**CITY OF ROLLINGWOOD  
ROLLINGWOOD PARK DESIGN GROUP MEETING  
AGENDA**

2. Discussion and possible action on design options, projected costs, and next steps for the Rollingwood Park parking lot, entrance design, and a separate off-leash area

## MEMORANDUM

Re: Rollingwood Park Upper Parking Lot – Pavement Option Drainage and Pavement Considerations

**A** Section - Concrete Curb and Gutter (with True Grid)  
 Scale 1 1/2" = 1'-0"

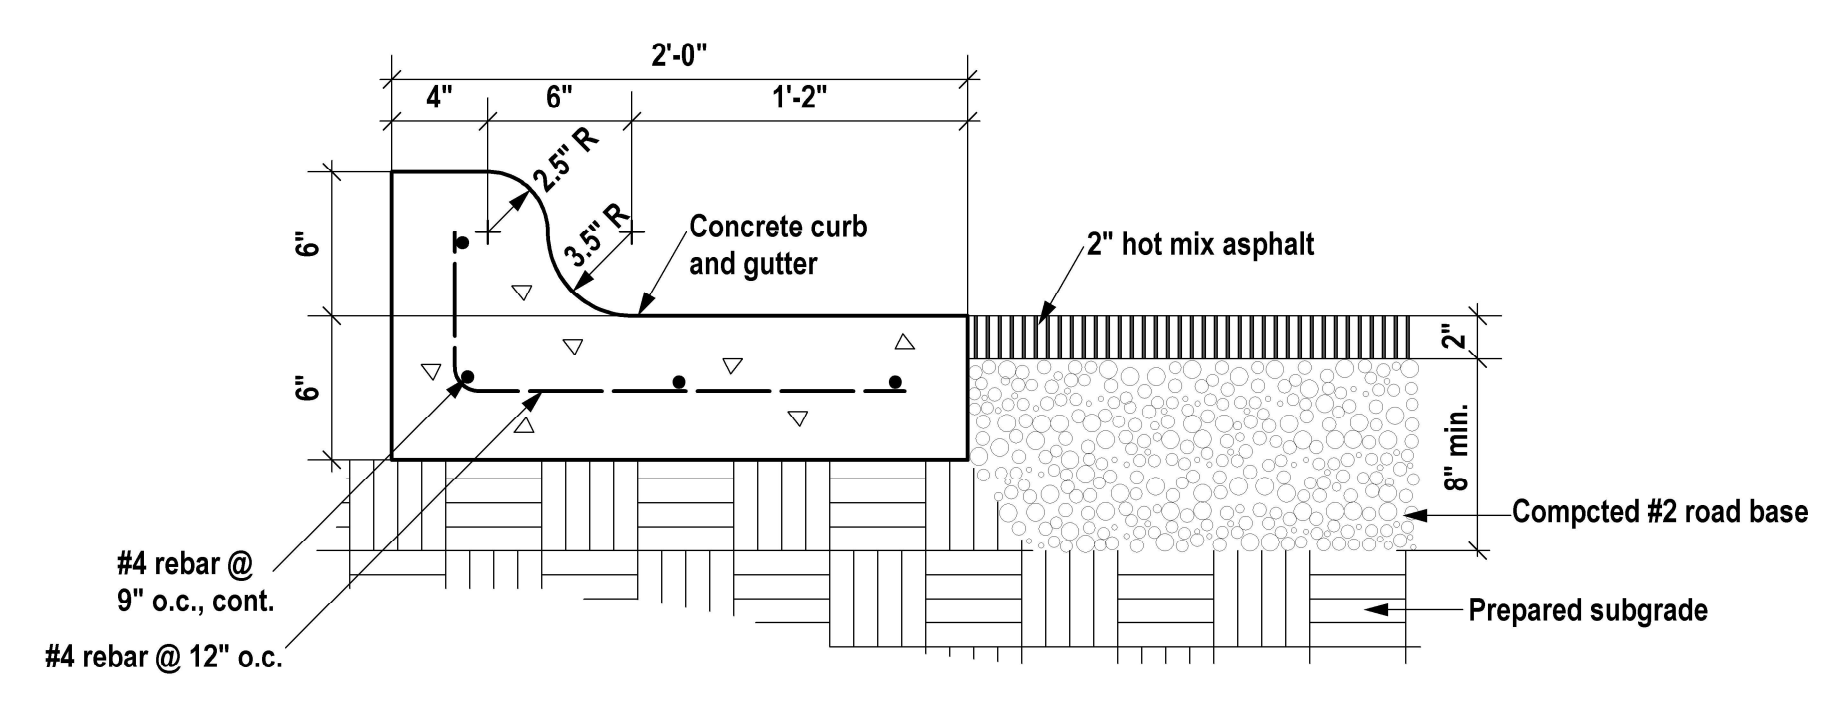
The pervious paver section as shown on the Sitedesign plans includes an engineered open-graded aggregate reservoir and an underdrain system that captures and slowly releases stormwater. Based on the planning-level 50% impervious assumption for vehicular TRUEGRID areas, the combination of reservoir storage, controlled release, and the existing impervious baseline of the upper parking lot may allow this option to satisfy DCM Section 4.1 without a separate detention facility, subject to confirmation through hydrologic calculations during design.

Anticipated service life is 25 years or more with consistent maintenance, assuming use of the TRUEGRID PRO PLUS commercial-duty product and an engineered pavement section appropriate for public parking lot use. TRUEGRID PRO PLUS is identified by the manufacturer as a commercial-use product for parking lots and heavy loads, with load capacity exceeding H20/HS20 rating when properly filled and installed. The current Sitedesign plans identify TRUEGRID pervious pavers, but the final design should specifically confirm TRUEGRID PRO PLUS or an approved equal, along with the aggregate reservoir section, underdrain configuration, edge restraint, infill material, and design vehicle loading.

TRUEGRID PRO PLUS is identified by the manufacturer as ADA compliant; however, gravel-filled permeable paver areas should still be specifically detailed and reviewed to confirm that accessible parking spaces and accessible routes provide a firm, stable, and slip-resistant surface. A hybrid section with concrete at the ADA-accessible parking stalls remains the lower-risk solution and is consistent with the Sitedesign plans.

For planning purposes, the installed cost of a TRUEGRID PRO PLUS system is assumed to be on the order of \$15 to \$20 per square foot, pavement system only, based on the plan detail showing TRUEGRID with gravel infill over a 6-inch layer of angular stone and prepared subgrade. This estimate should be confirmed by Sitedesign or a contractor during final design based on the final section thickness, stone gradation, underdrain layout, edge restraint, excavation, and outlet configuration

- If minimizing drainage mitigation and advancing a more environmentally sensitive pavement approach are the primary drivers, Option 1, TRUEGRID PRO PLUS pervious pavers, is the recommended option. It provides the greatest opportunity to reduce runoff and support TCEQ Chapter 213 water quality compliance, based on a planning assumption of 50% impervious cover for vehicular-use areas. These benefits are subject to final design acceptance and long-term maintenance. A hybrid section with concrete at the ADA-accessible parking stalls is recommended.

**A1** Alternate Section - Concrete Curb and Gutter (with asphalt)  
 Scale 1 1/2" = 1'-0"

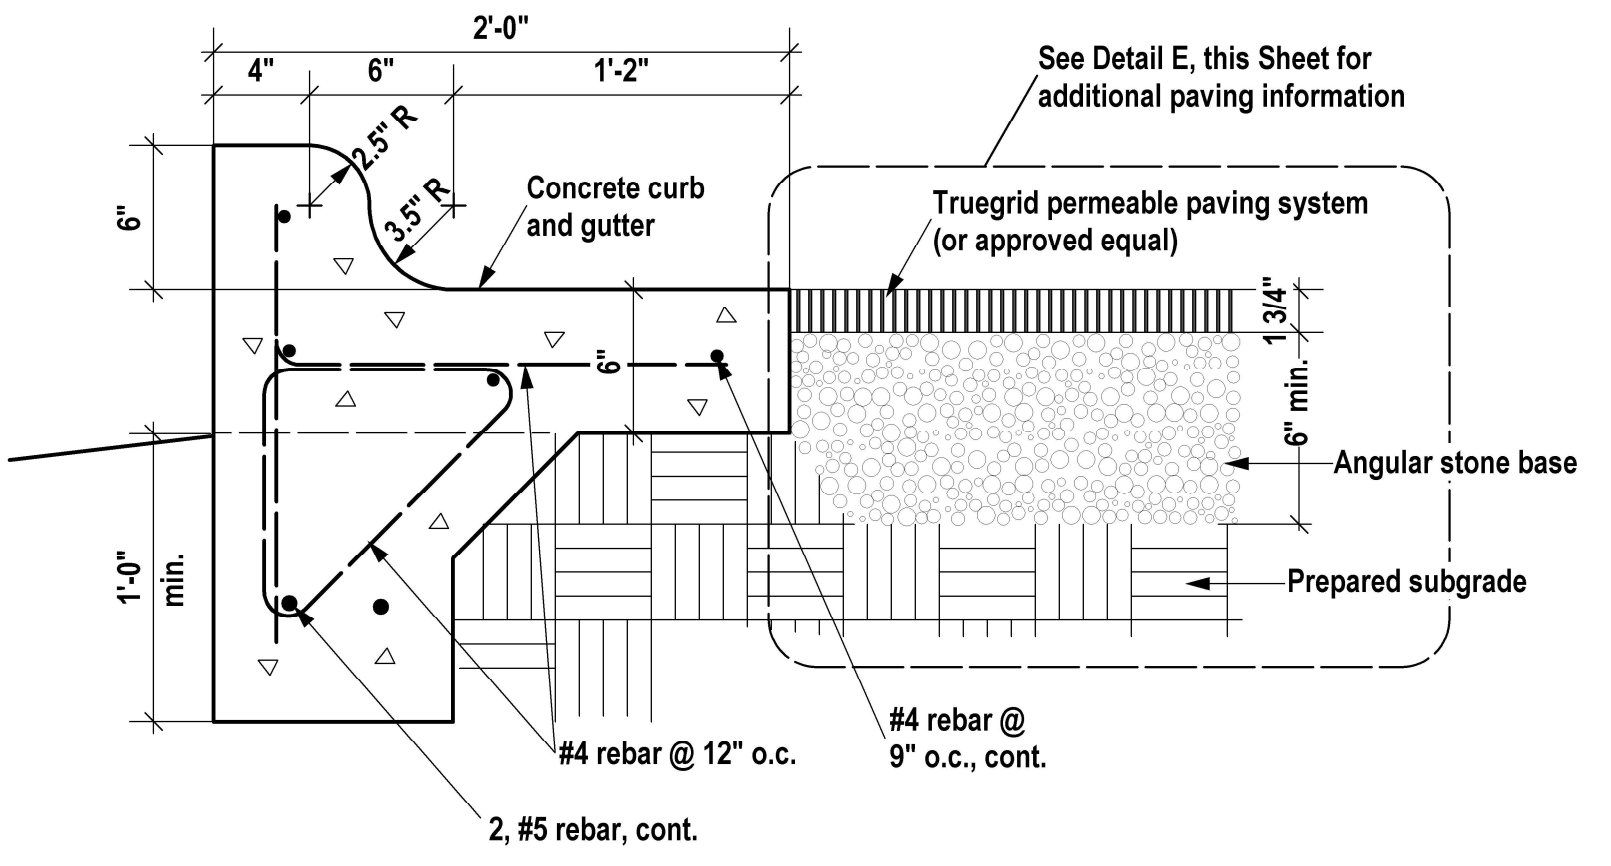
For planning purposes, installed costs for asphalt are assumed to be on the order of \$15 to \$20 per square foot, pavement only. This range is based on recent City bid pricing for a heavy-duty asphalt section consisting of approximately 10 inches of Type B hot mix asphaltic concrete pavement and 2 inches of Type D hot mix asphaltic concrete pavement. If a thinner standard parking lot section over compacted aggregate base is selected during final design, the asphalt pavement cost may be lower.

Performance risks include rutting under sustained heat, edge raveling, cracking, and faster deterioration relative to concrete. These risks can be mitigated with a thicker base or pavement section, but doing so would increase construction cost.

- If a conventional pavement section and reduced maintenance complexity are the primary drivers, Option 2, asphalt, is a viable option. Asphalt should be considered most favorably if the final design can match the existing asphalt and compacted base footprint as closely as practical, thereby avoiding or minimizing additional drainage mitigation requirements under DCM Section 4.1. The City should anticipate periodic crack sealing, seal coats, and an eventual overlay within the 15-to-20-year service life. If new or modified impervious cover is not otherwise addressed by an accepted BMP or existing approval, a separate water quality BMP may also be required for applicable TCEQ Chapter 213 compliance.

*Figure 1 - Rollingwood Park Topography*

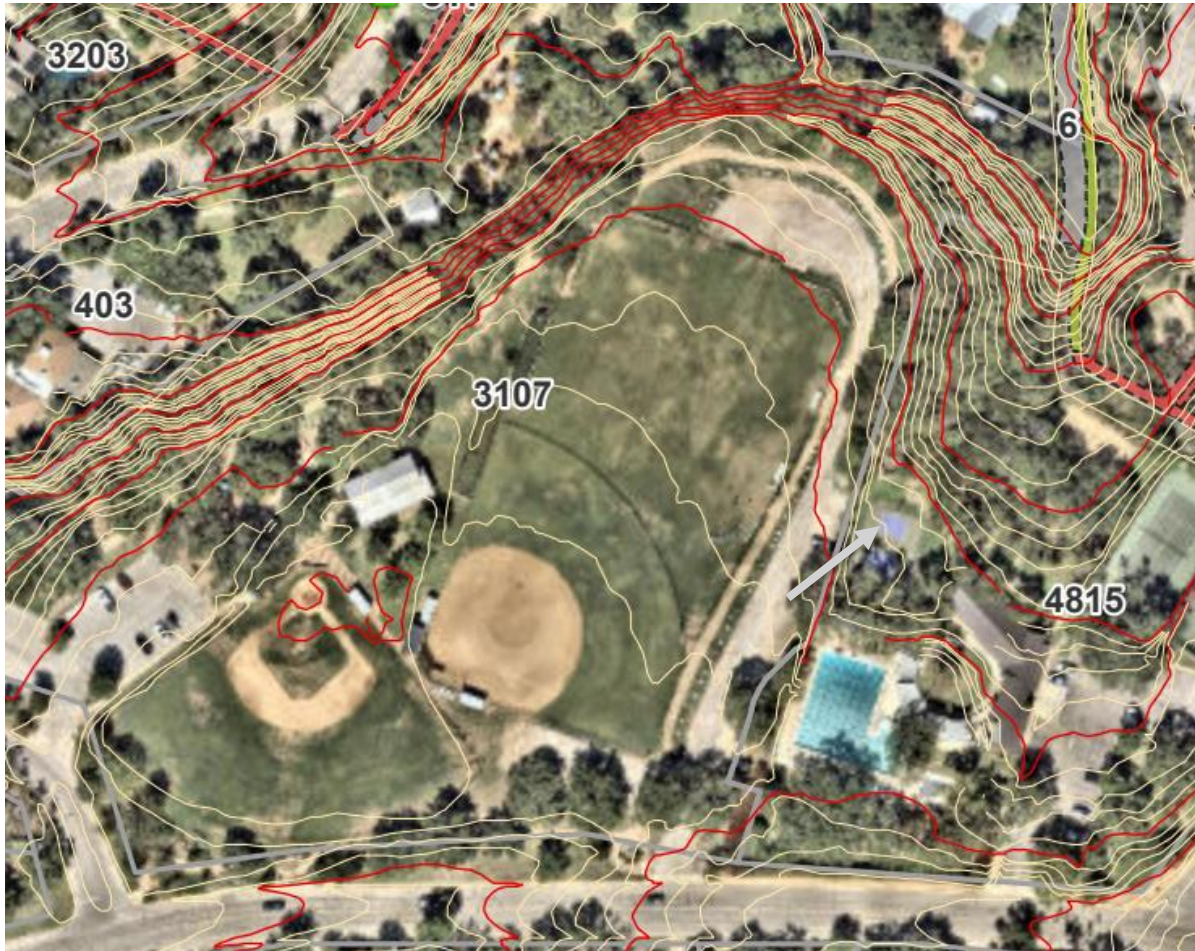
An additional drainage consideration specific to this site is the discharge condition along the eastern property line. As illustrated in Figure 1, the existing topography indicates that runoff from the upper parking area sheet flows generally to the east and discharges across the eastern property line onto the adjoining Westlake Athletic Club (WAC) property. There is no recorded drainage easement across the WAC property, and runoff originating from Rollingwood Drive is assumed not to be conveyed onto or treated within the parking lot site. The proposed landscape plan shows the underdrain system discharging at the northeast corner of the parking improvements.

The selected pavement option must therefore include drainage controls sufficient to manage discharge at the eastern property line such that post-development peak flows comply with DCM Section 4.1 and the overall discharge condition, including runoff concentration, timing, volume, erosion potential, and water quality, does not adversely impact the WAC property relative to existing conditions. If concentrated discharge is proposed across the property line, a drainage easement or written downstream acceptance may be required.
